Decision Date: **September 28, 2022**

Case No.: AA-2022-2133-PMLA-CC
Address: 6064-6066 West Saturn Street
Planning Area: Wilshire
Zone: RD1.5-1-O
D.M.: 129B173
C.D.: 10 – Hutt
CEQA: ENV-2022-2134-CE
Legal Description: Lot 48, TR7887 Tract

In connection with the approval of Parcel Map No. AA-2022-2133-PMLA-CC the Advisory Agency of the City of Los Angeles, pursuant to Sections 66473.1, 66474.60, .61 and .63 of the State of California Government Code (the Subdivision Map Act), makes the prescribed findings as follows:

LOS ANGELES DEPT. OF CITY PLANNING
SUBMITTED FOR FILING
PARCEL MAP

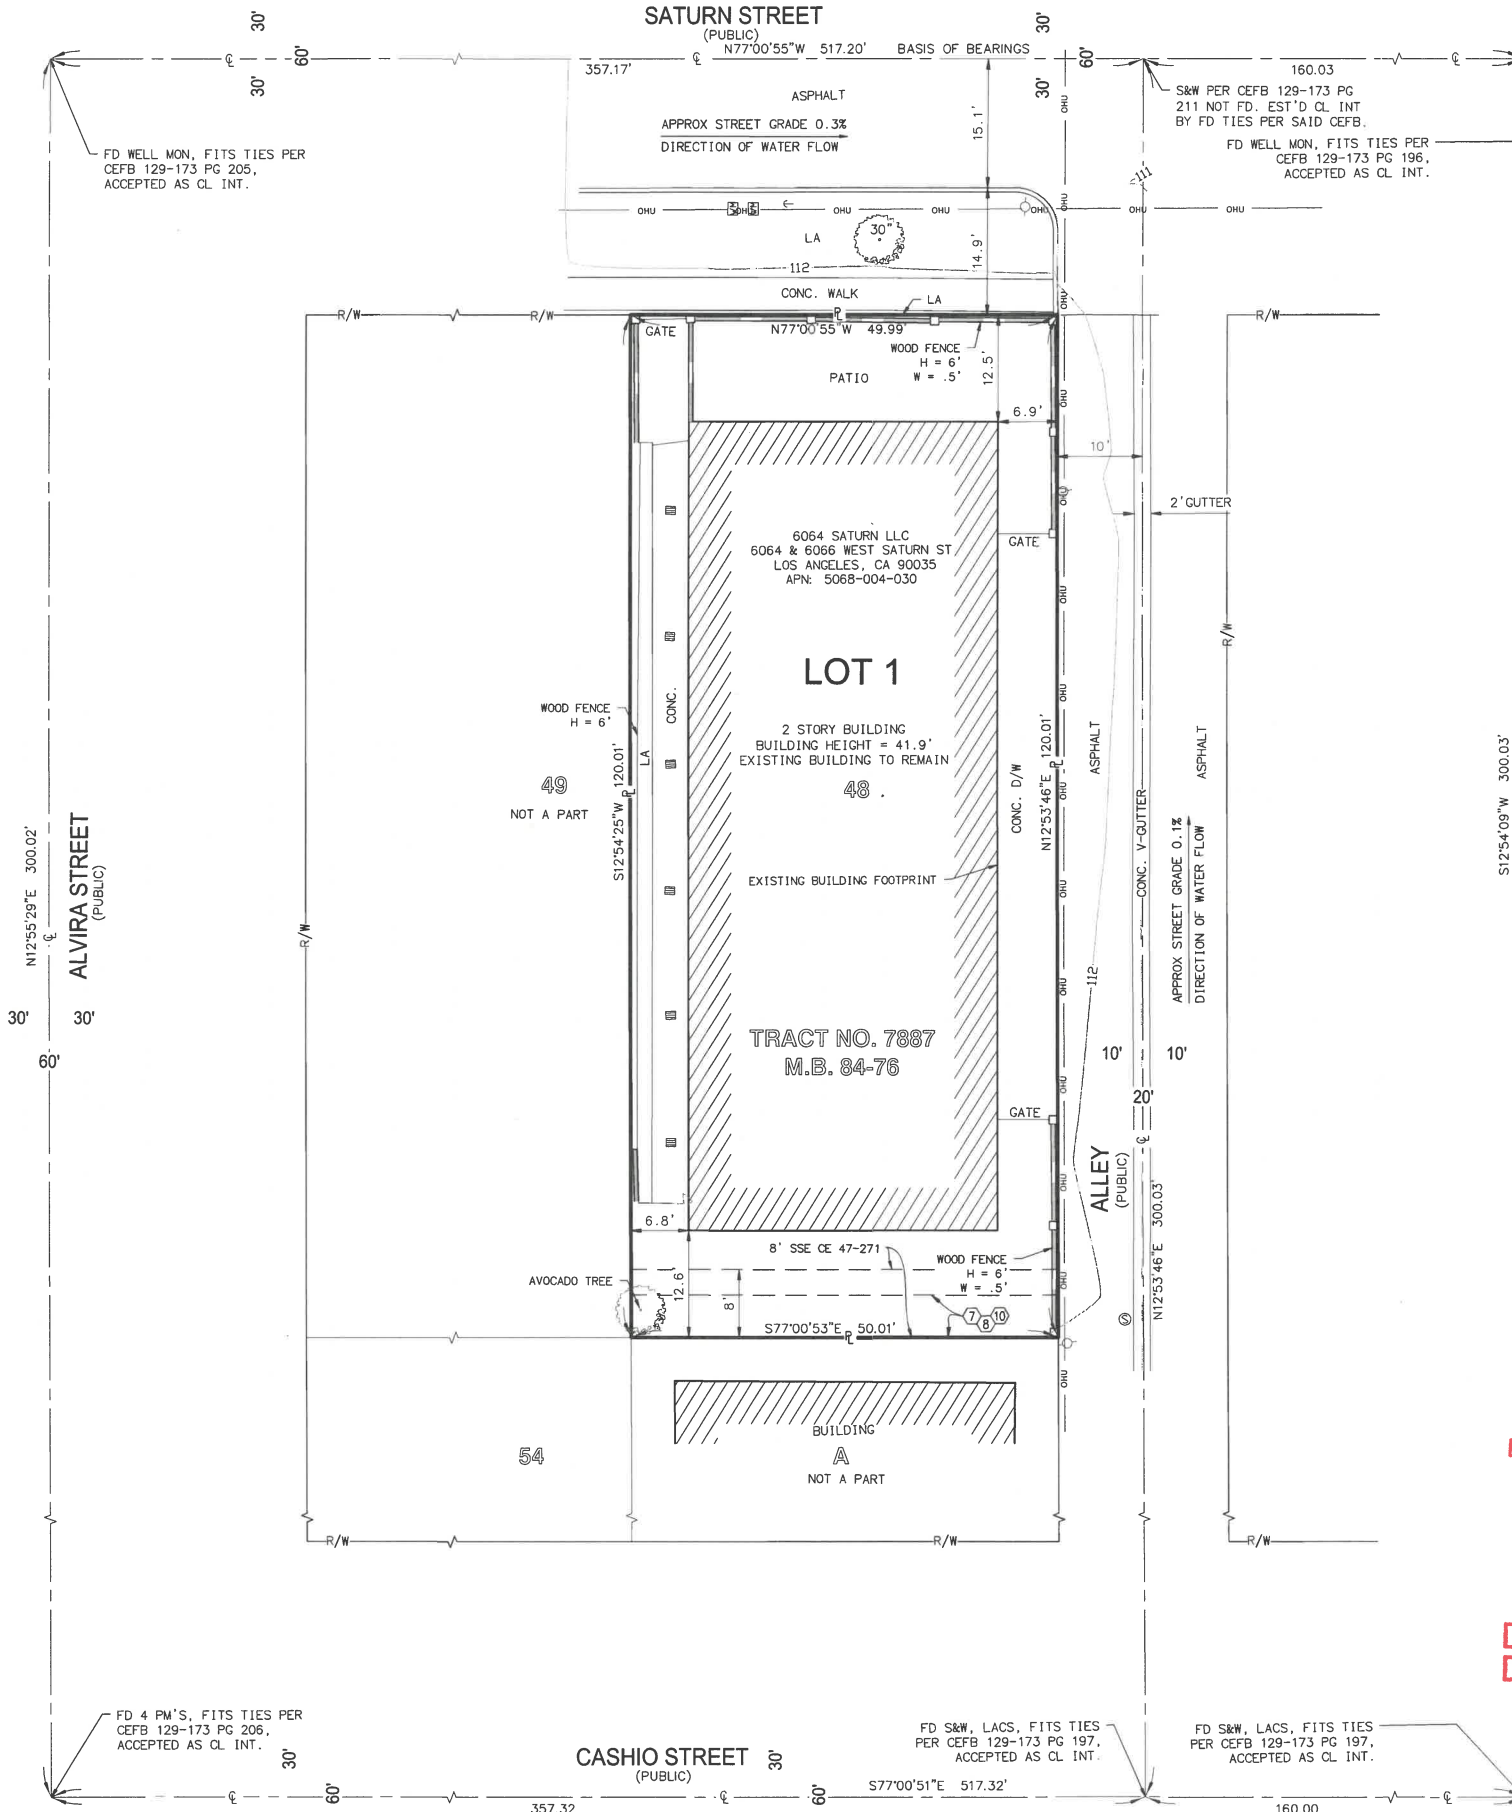
The submitted Map may not comply with the number of parking spaces required by Section 12.21 A 4 (a) based on number of habitable rooms in

The submitted Map may not comply with the number of guest parking spaces required by the Advisory Agency.

There are easements contained within the property. Any proposed development in close proximity to the easements must secure Department of Public Works approval.

reviewed the subject Parcel Map No. AA-2022-2133-PMLA-CC and have required to show all street/alley improvement(s) as required by Bureau of Engineering. Front and side yard requirements shall be required to comply with current code as measured from new property lines after dedication(s). As conditioned, no violations of Chapter IX of the Los Angeles Municipal Code will exist.

- b. Provide a minimum of 2 off-street parking spaces per dwelling unit, one (1) covered and one (1) uncovered, for a total of four (4) parking spaces onsite.

- (i) That the following improvements be either constructed prior to recordation of the final map or that the construction be suitably guaranteed:
 - a) Improve Saturn Street adjoining the subdivision by the construction of the following:

- 1) An integral concrete curb and gutter, and a 5-foot concrete sidewalk and landscaping of the parkway.
 - 2) Any necessary removal and reconstruction of existing improvements.
